## ALERT SERVICE BULLETIN

**505-24-38**

**MODEL AFFECTED:** 505

**SUBJECT:** VERTICAL STABILIZER ASSEMBLY, TOP END CAP ASSEMBLY, INSPECTION OF.

**Figure 1 – NAV/VOR/GS Antenna and Tuning Weight Installation  
(helicopter serial numbers 65011 through 65169)**

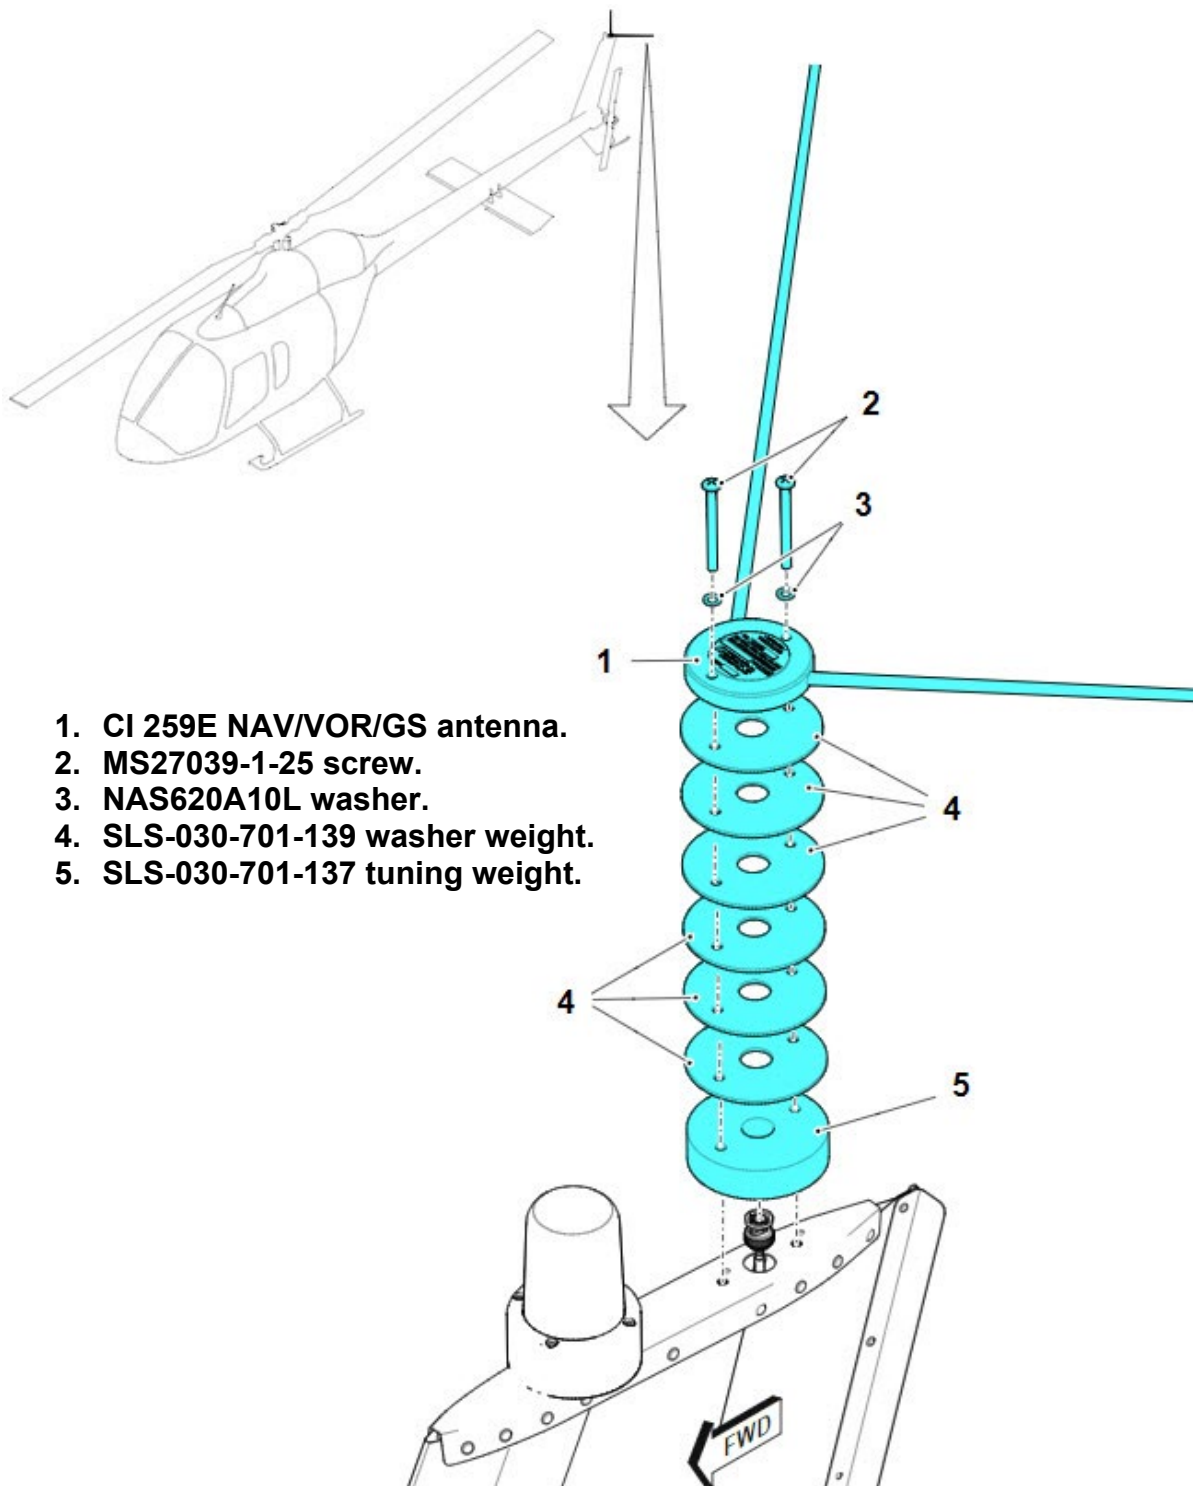
Helicopters serial number 65011 through 65169 have been delivered with five tuning weight washers SLS-030-701-139 and one tuning weight SLS-030-701-137 installed. Serial numbers 65170 and subsequent will have one tuning weight SLS-030-701-141 installed (Figures 1 and 2).

9. Install the tuning weight(s) to the surface of the top end cap assembly. Apply sufficient torque to the retaining screws (2, Figure 1 and 2) until sealant (C-251) squeeze-out occurs between the top end cap assembly and the tuning weight. Allow the sealant to cure.
10. Once the sealant (C-251) has cured, remove the tuning weight(s).
11. Remove the tape (C-454) from the top end cap assembly.

**Figure 3 – Area of Detailed inspection**

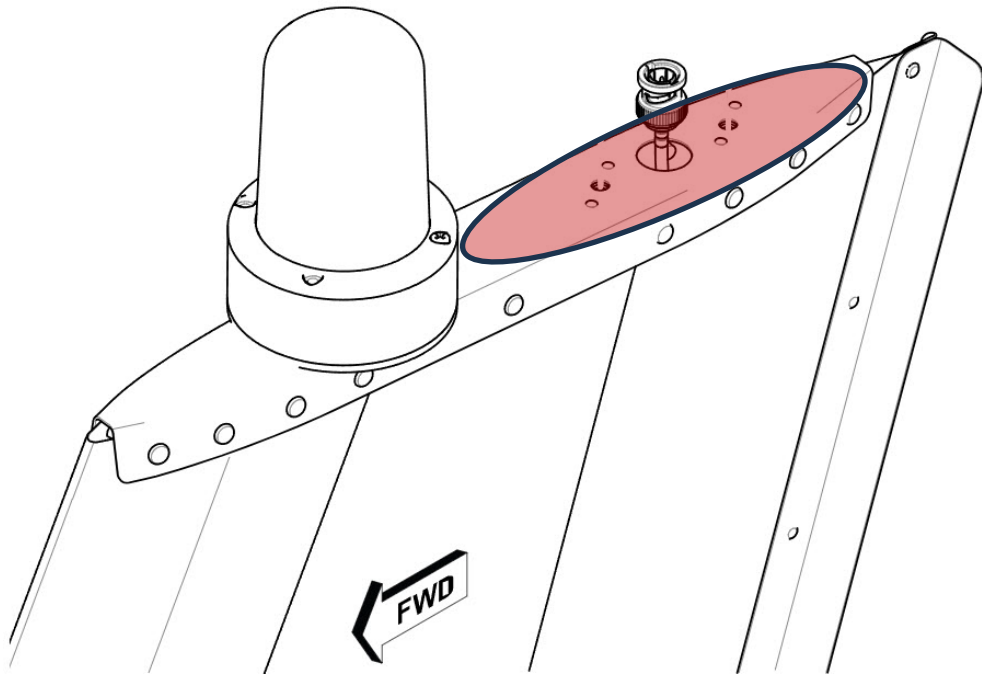
2. Remove the NAV/VOR/GS antenna and tuning weight(s) ([DMC-505-A-34-52-02-00A-520A-A](#)).
3. Secure the NAV/VOR/GS antenna coaxial cable so that it does not fall into the vertical stabilizer assembly.
4. Remove any residual sealant (C-251) that may be present on the top end cap and tuning weight.
5. Using isopropyl alcohol (C-385) clean the surface of the top end cap assembly and allow to dry.
6. Perform a detailed inspection for any cracks of the top end cap assembly in area indicated (Figure 3).
  - a. If no cracks are found, go to step 7.

4. Perform a detailed inspection for any cracks of the top end cap assembly in area indicated (Figure 3).
  - a. If no cracks are found, go to step 5.
  - b. If a crack is found, replacement of the cracked top end cap assembly, by accomplishment of **PART II**, shall be accomplished prior to next flight.

- b. If a crack is found, replacement of the cracked top end cap assembly, by accomplishment of **PART II**, shall be accomplished prior to next flight. Complete the remaining steps of **PART I** following accomplishment of **PART II**.

**Figure 4 – Area to Apply Tape (C-454)**

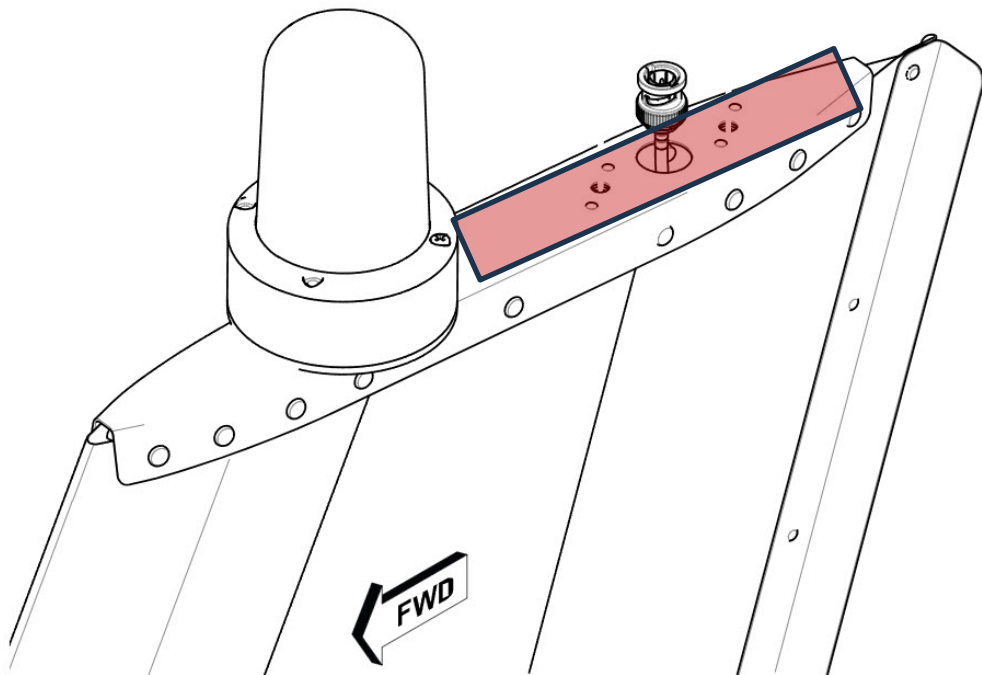
Ensure that the full surface of the top end cap assembly that is exposed is covered with the tape (C-454) preventing sealant (C-251) squeeze-out sticking to the surface. Tape may also be extended to the side surfaces of the top end cap assembly.

7. Apply tape (C-454) to the top end cap assembly in the area indicated (Figure 4).

**Figure 5 – Location of Rivets  
(left side shown – right side is the same)**

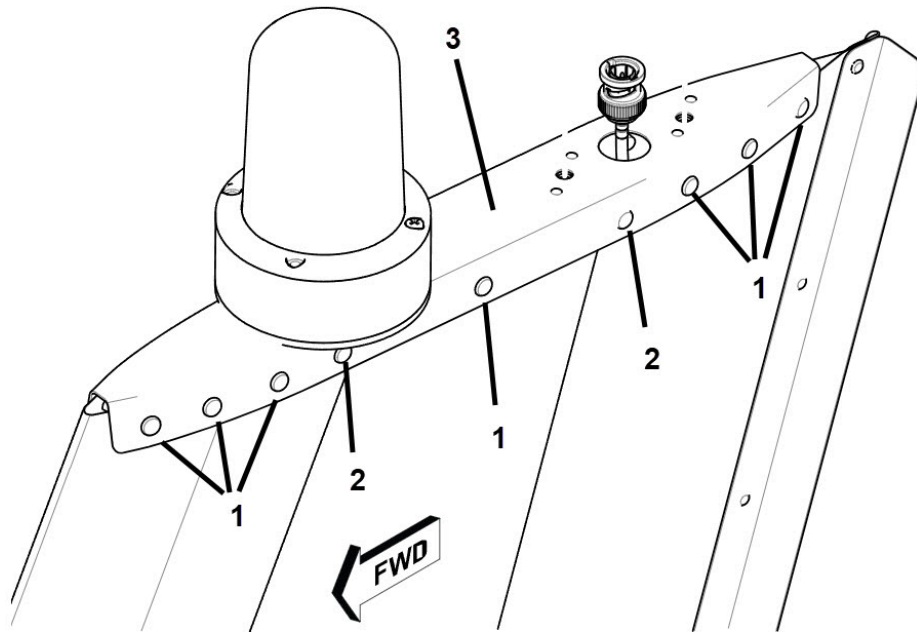
1. Prepare the helicopter for maintenance.
2. If not already accomplished, remove NAV/VOR/GS antenna and tuning weight(s) ([DMC-505-A-34-52-02-00A-520A-A](#)).
3. Remove anti-collision light assembly ([DMC-505-A-33-43-01-00A-520A-A](#)).
4. Remove the rivets (1 and 2, Figure 5) holding the top end cap assembly (3) to the vertical stabilizer assembly.

5. Remove the top end cap assembly (3).
6. Remove any residual sealant (C-251) that may be present on the vertical stabilizer assembly.
7. Using isopropyl alcohol (C-385) clean the surface of the top end cap assembly and allow to dry.
8. Apply sealant (C-251) to the faying surfaces of the top end cap assembly that will be in contact with the vertical stabilizer assembly.

9. Insert NAV/VOR/GS antenna coaxial cable connector (3430AT1P1) through the opening in the replacement top end cap assembly (3, Figure 5).
10. Install replacement top end cap assembly (3) using the rivets (1 and 2) indicated, wet installed with sealant (C-251).
11. Apply sealant (C-251) around the top end cap assembly and the vertical stabilizer assembly, including the openings at each end of the top end cap assembly (Figure 6).
